Well Name: SAN JUAN 27-5 UNIT	Well Location: T27N / R5W / SEC 35 / NESW / 36.52763 / -107.32979	County or Parish/State: RIO ARRIBA / NM
Well Number: 144	Type of Well: CONVENTIONAL GAS WELL	Allottee or Tribe Name:
Lease Number: NMSF079439A	Unit or CA Name: SAN JUAN 27-5 UNIT--DK	Unit or CA Number: NMNM78409A
US Well Number: 3003920467	Well Status: Producing Gas Well	Operator: HILCORP ENERGY COMPANY

Sundry ID: 2724905

Type of Action: Plug and Abandonment

NOTICE OF INTENT TO PERMANENTLY ABANDON

San Juan 27-5 Unit 144 - PROPOSED P&A SCHEMATIC

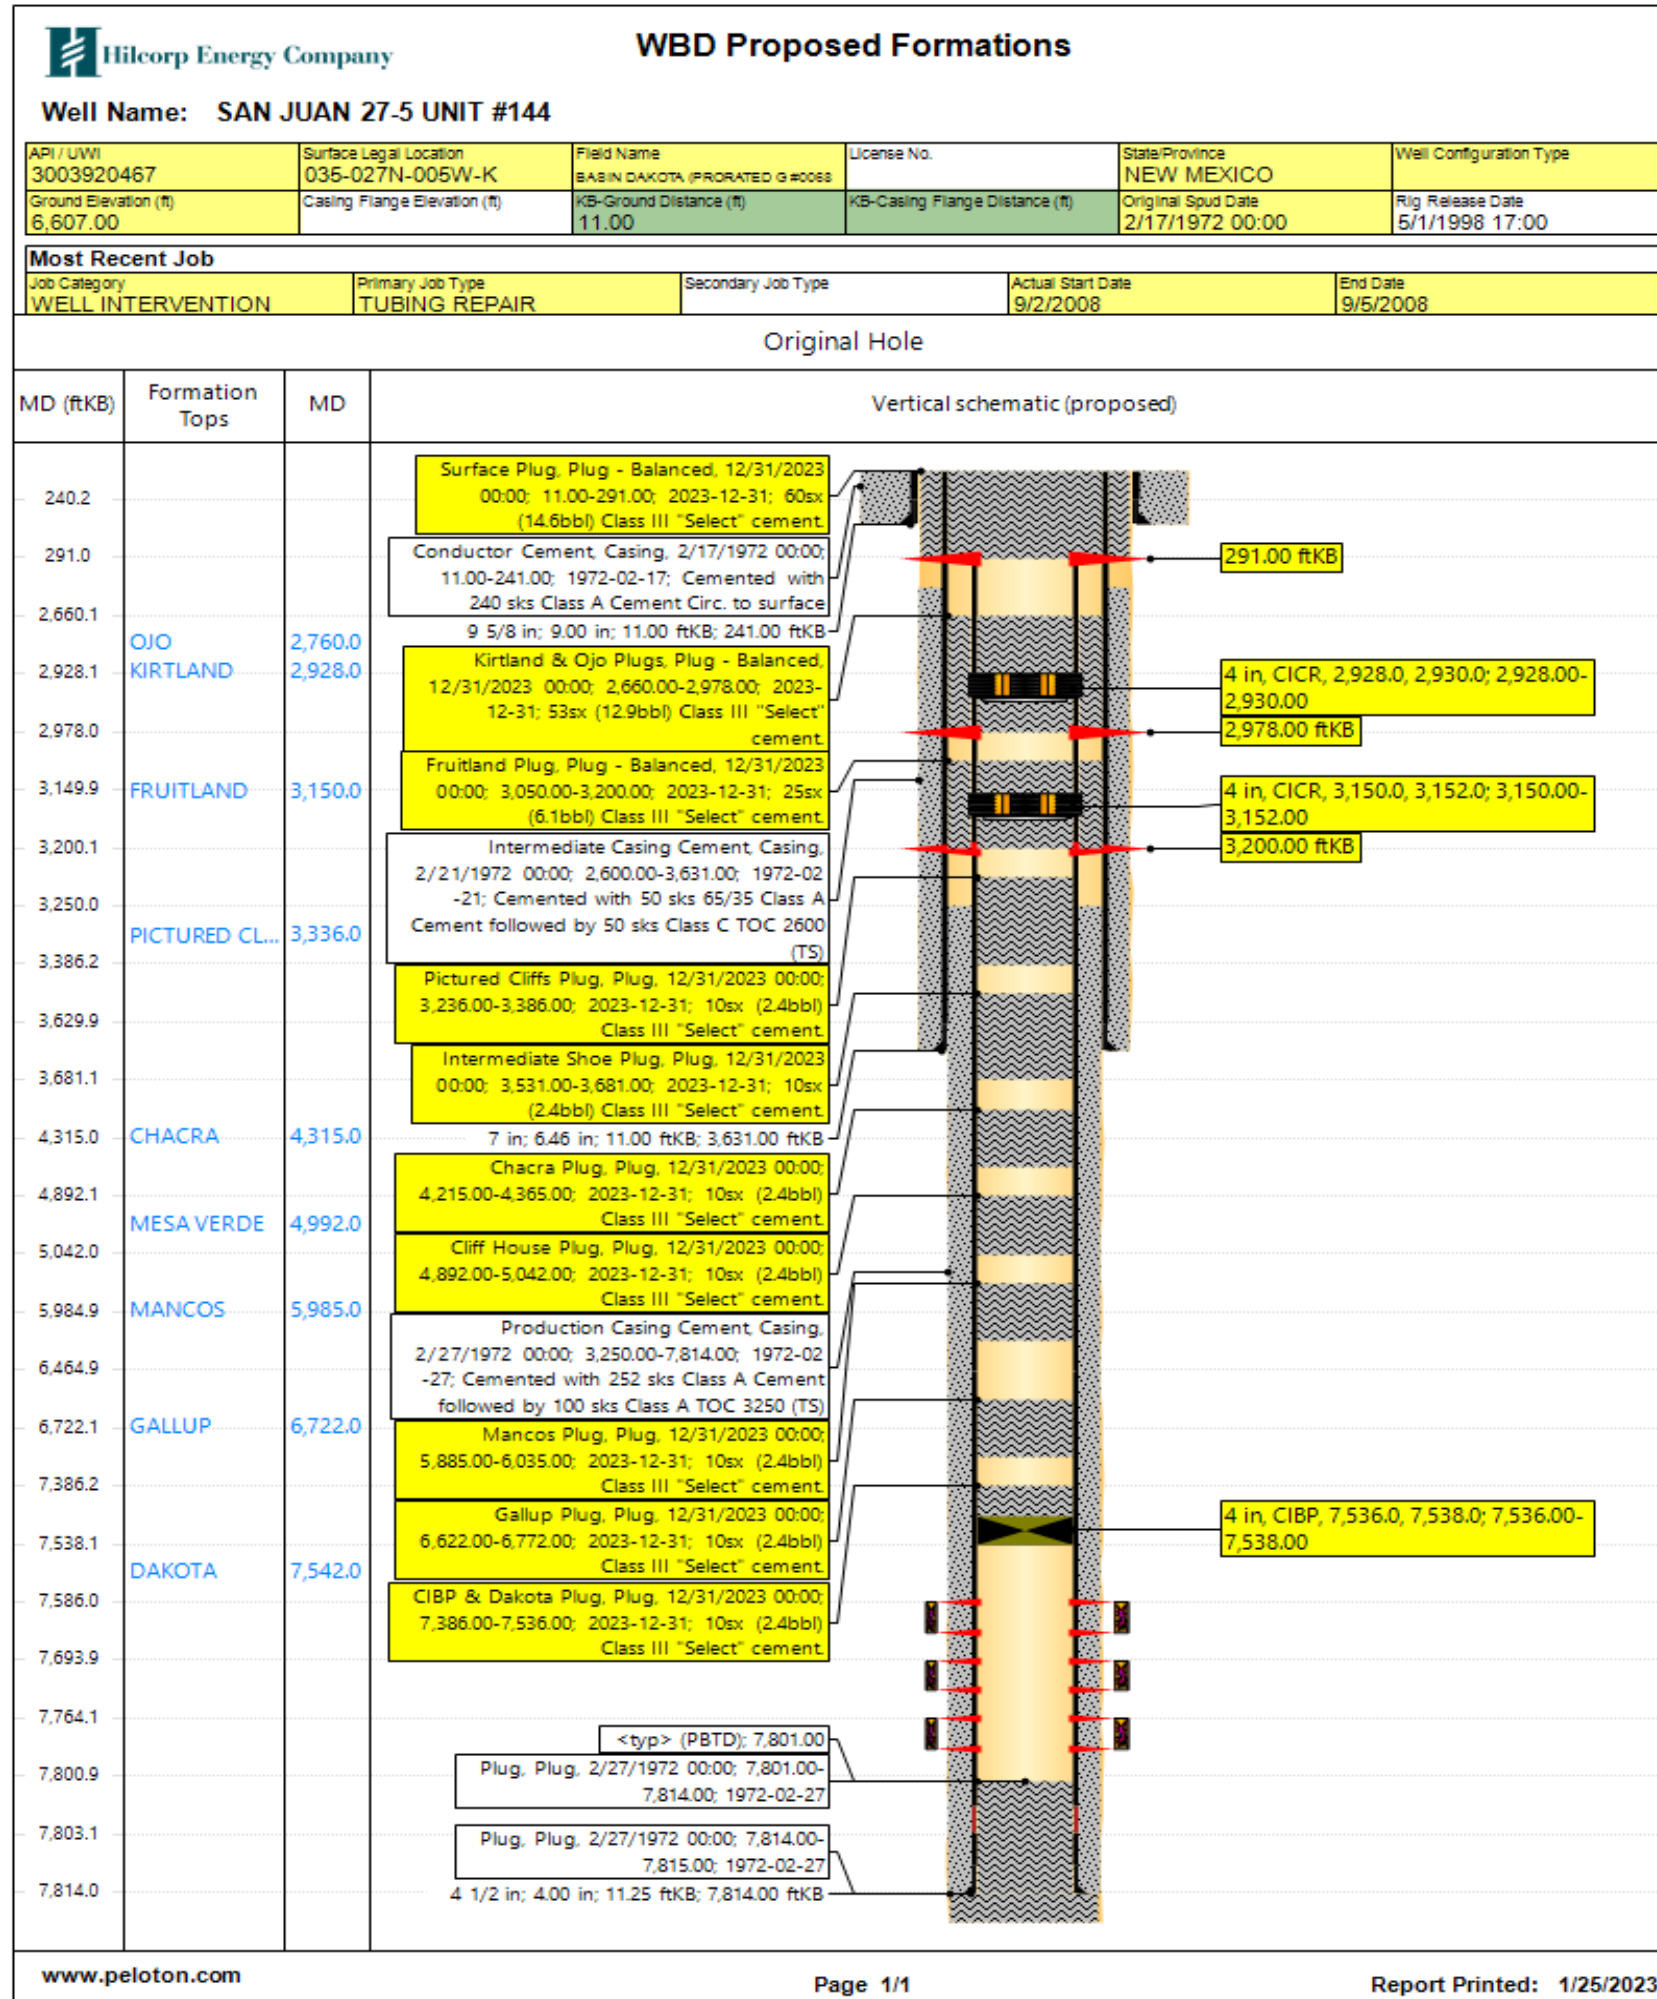
- Sundry ID: 2724905
- BLM pick for the Dakota formation top varies from Operator. No plug change required.
- Add an inside/outside plug to cover the Nacimiento formation top at 1292'.
- Dakota perms 7586' – 7792'.

1. Plugging operations authorized are subject to the attached "General Requirements for Permanent Abandonment of Wells on Federal and Indian Lease."
2. The following modifications to your plugging program are to be made:
 - a. Add an inside/outside plug to cover the Nacimiento formation top at 1292'.
3. Farmington Office is to be notified at least 24 hours before the plugging operations commence at (505) 564-7750.
